DUKE POWER COMPANY

Re: Catawba Nuclear Station
Docket Nos. 50-413 and 50-414

In order to facilitate the completion of the review of the Catawba FSAR, Duke Power Company is transmitting herewith responses, revised responses, or partial responses to the following FSAR questions:

Figure 123.3-1

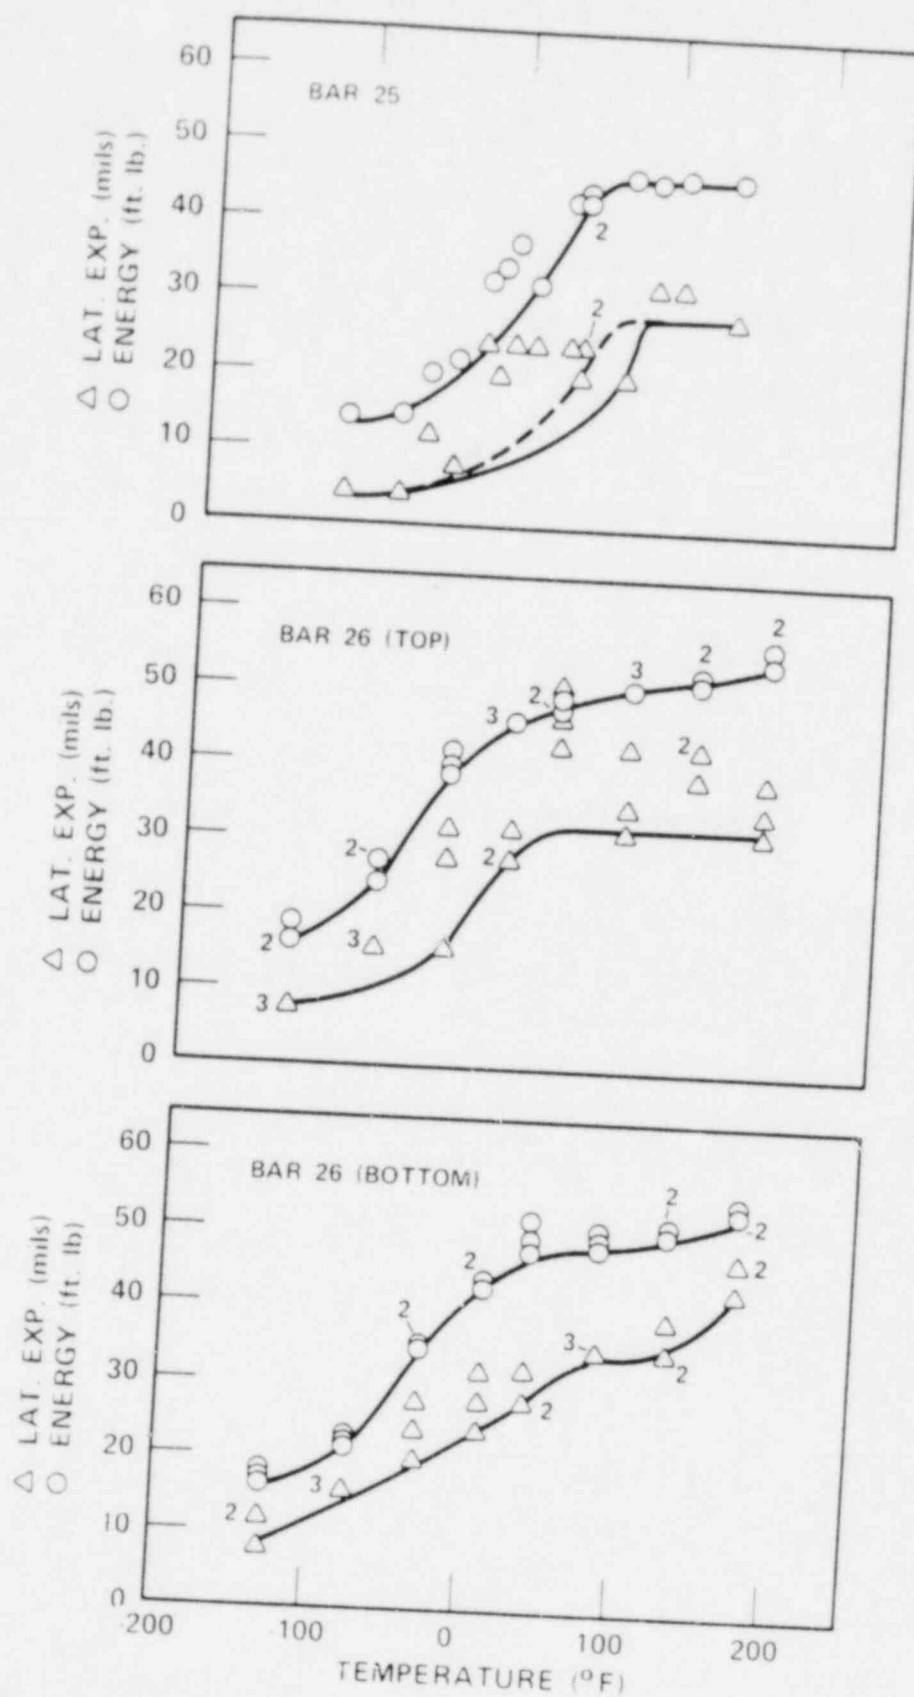
Provide material test data, analysis or data from the literature to demonstrate that bolts from heat number 35674 which had CVN values of 29 to 38 ft-lbs and 8 to 12 mils LE at 10°F, would meet the requirements of NB-2333 of the ASME Code (45 ft-lbs and 25 mils L.E. at the preload or lowest service metal temperature which ever is less). The sample material which demonstrates that the heat no. 35674 bolts will comply with the CVN requirements of NB-2333 of the ASME Code, must have been fabricated to an equivalent material specification and heat treated to an equivalent metallurgical condition as the material from heat no. 35674 bolts.

The Charpy data shown for Bar 25T in Table 5.3.1-6 has been changed to correct a typographical error. The 29 foot pounds shown originally should have been 39 foot pounds. Additional Charpy data from heat number 35674 is shown in Table Q123.3-1. This same data is shown graphically in Figure Q123.3-1. One of these 128 data points (MLE for Bar 25 at 68°F) appears uncharacteristically low. Ignoring this one point, the curves of Figure Q123.3-1 demonstrate that this material would satisfy the requirement of later editions of the ASME Code for 45 foot pounds and 25 MLE at temperatures as low as 50°F.
